VA786-16-R-0160

ATTACHMENT B - TECHNICAL DRAWINGS

Project Title	WASHINGTON CROSSING NATIONAL CEMETERY
---------------	--

Drawing Title	Project Title	Project Number
Approved: Project Director	Location BUCKS COUNTY, PENNSYLVANIA	Building Number -
Date	Checked	Drawn
		926-M&R16-08-01

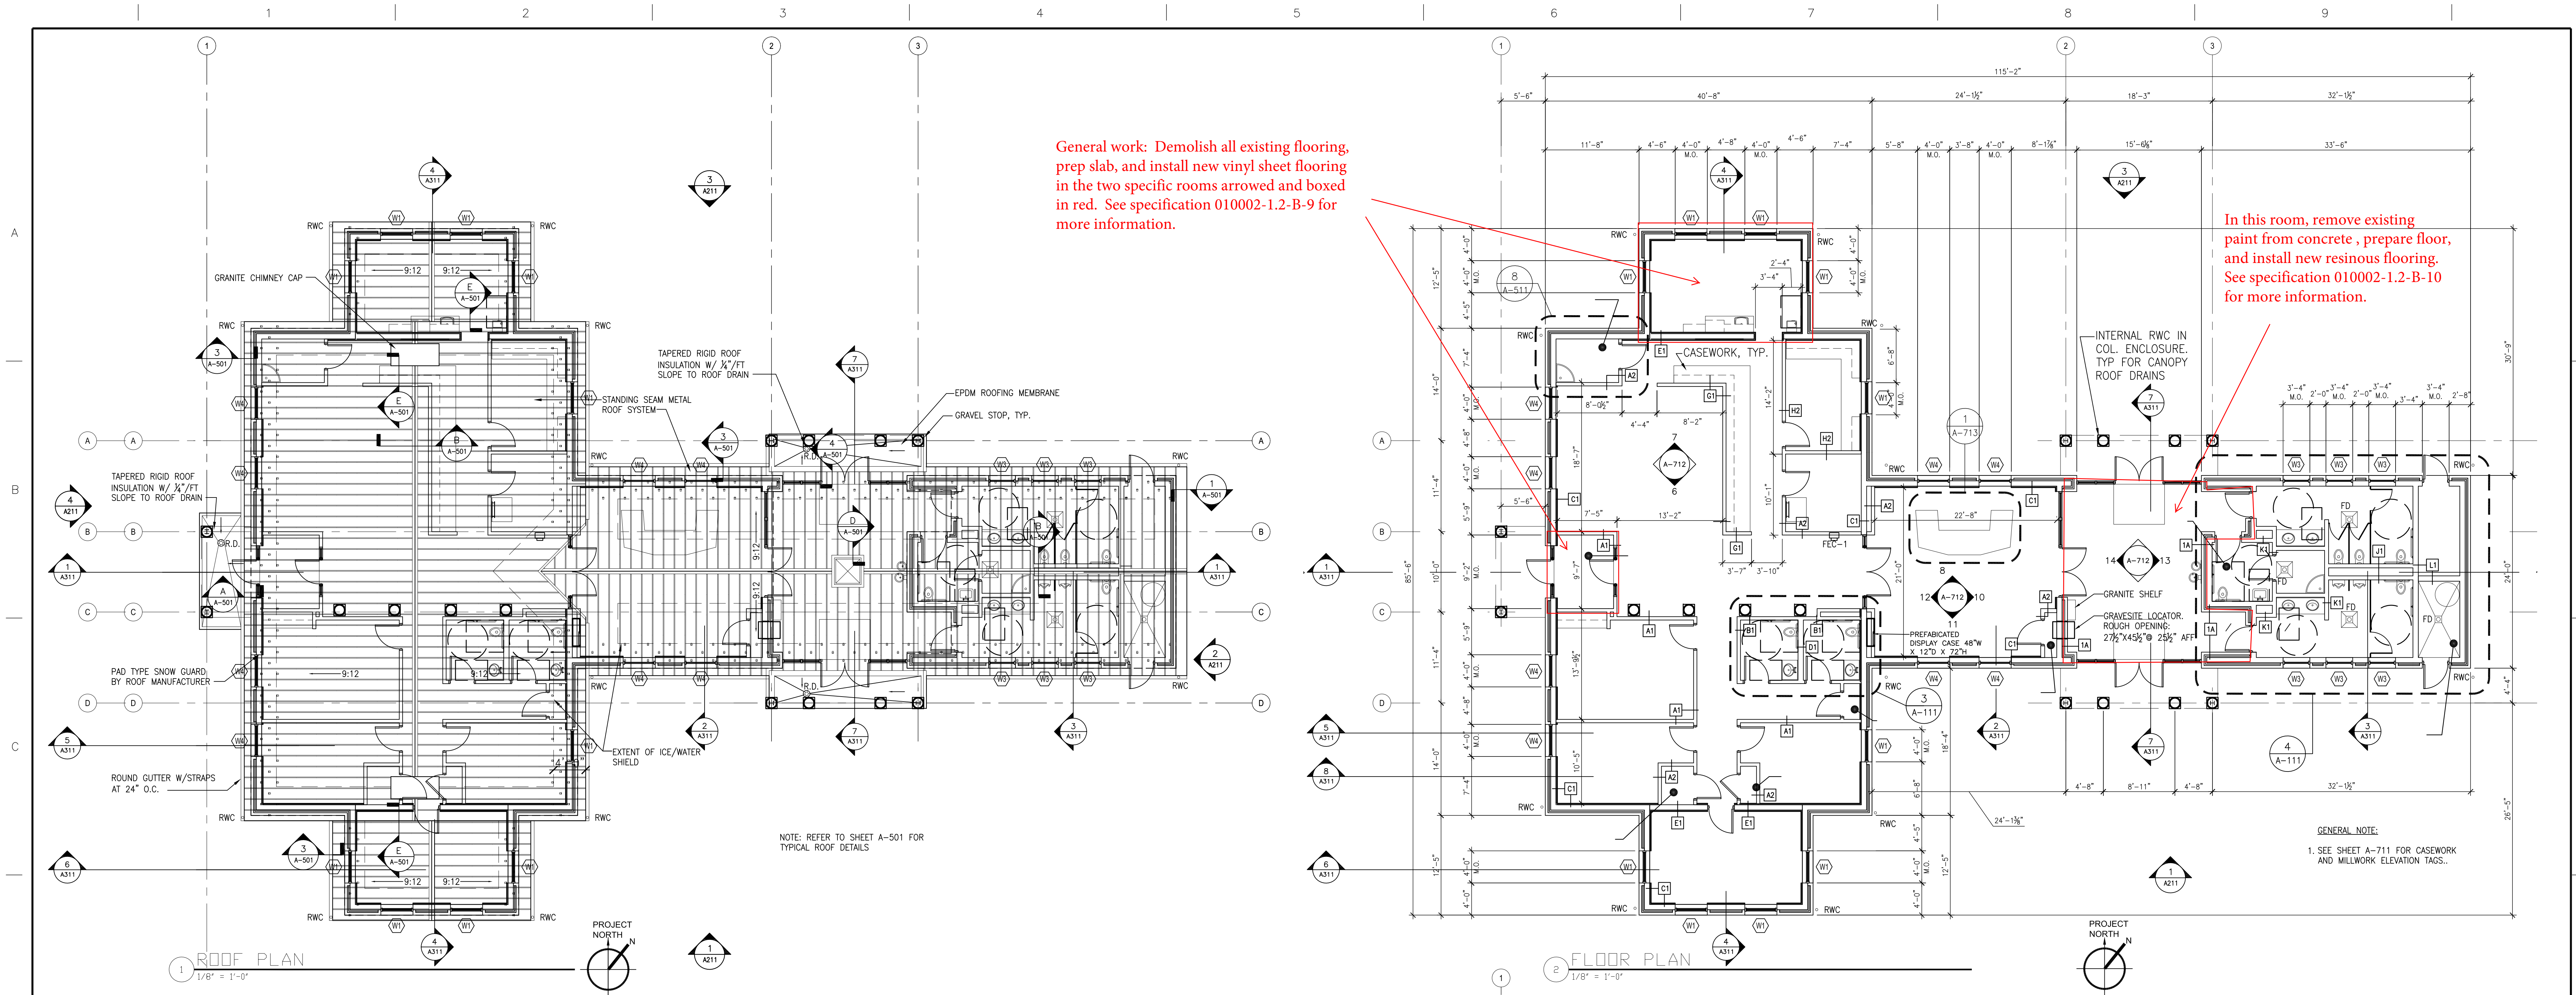
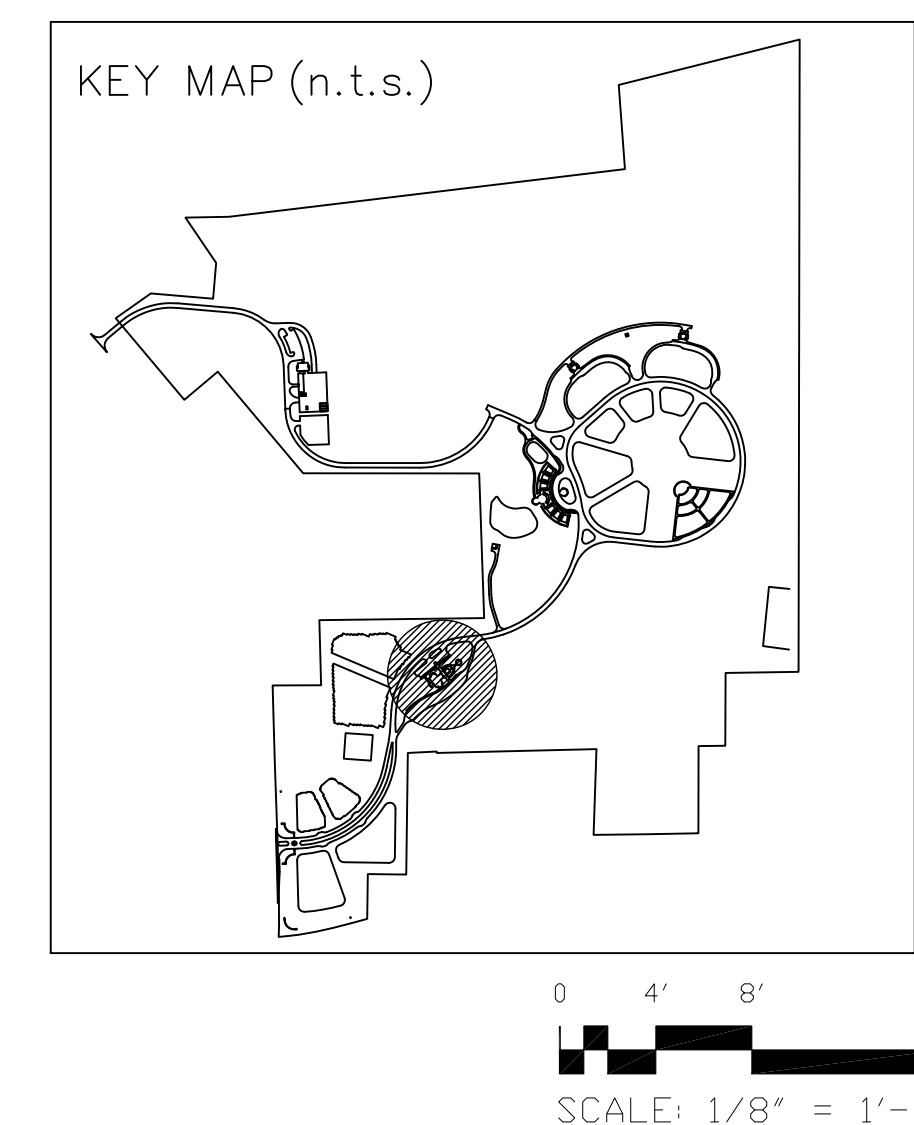
Circled doors require frost heave solution and slab work. See specification 010002-1.2-B-7 for more information.

General work: Demolish all existing flooring, prep slab, and install new vinyl sheet flooring on entire building's floor shown in this detail 2 Floor Plan. See specification 010002-1.2-B-9 for more information.

SEE SHEET C-201		ENGINEER		NATIONAL CEMETERY ADMINISTRATION		Drawing Title SITE PLAN (AREA B)		Project Title		Project Number	
						Approved: Project Director		Location BUCKS COUNTY, PENNSYLVANIA		Building Number	
								Date		Drawing Number	
								Checked		926-M&R16-08-03	
								Drawn

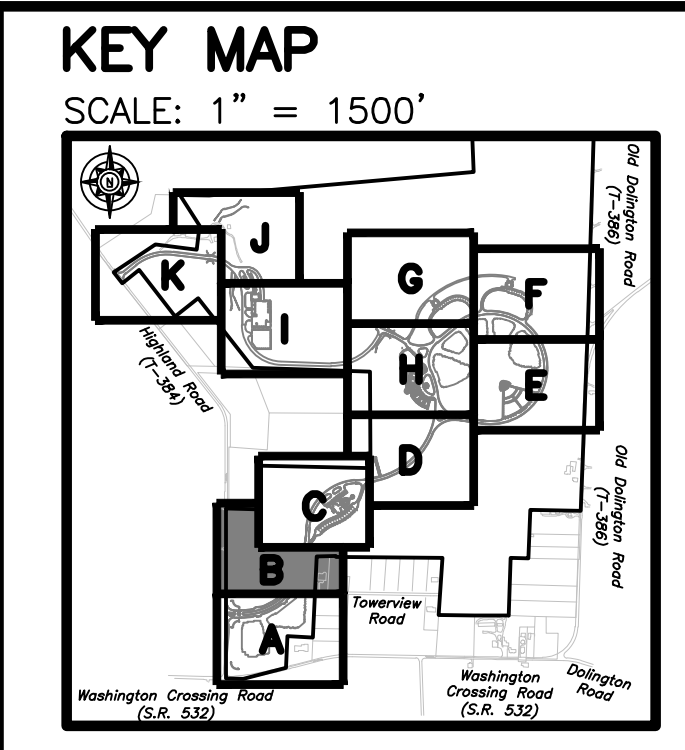
New work this sheet is limited to locating of underground utilities for this highlighted area. See specification 010002-1.2-B-8 for more information.
